STAFF REPORT
WEST ALLIS PLAN COMMISSION
Wednesday, February 22, 2023
6:00 PM

7. Site, Landscaping, and Architectural Plans for Boucher Lincoln, an existing Light Motor Vehicle sales use, at 3161 S. 108th St. (Tax Key No. 523-9986-010)

1 | Right Elevation
1/16" = 1'-0"

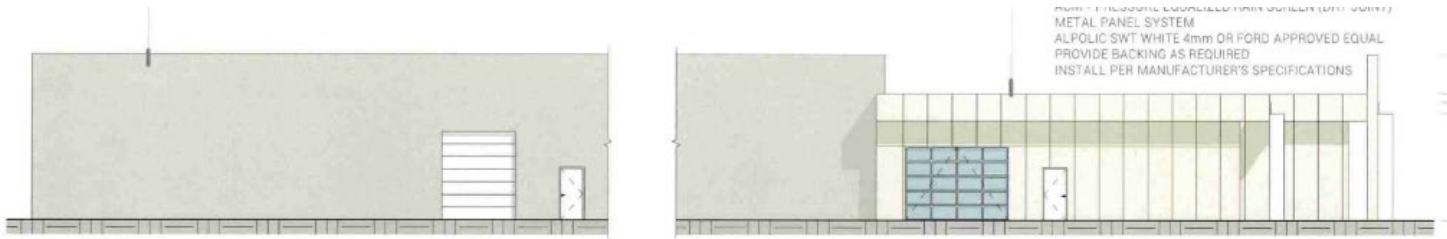
The proposed changes are prompted by a branding update requested by the Ford Motor Company. Various changes are proposed to the south, north, and east facades. The ACM paneling on the existing building will be re clad with porcelain wall cladding. A brown ACM metal panel system strip is to run along portions of the east and north façade. The brick towards the rear of the building is to be repainted as well.

The current signage area and the vertical element of the existing building is to be removed in the proposed plans. The proposed building is uniform in height. New signage is proposed on the east façade.
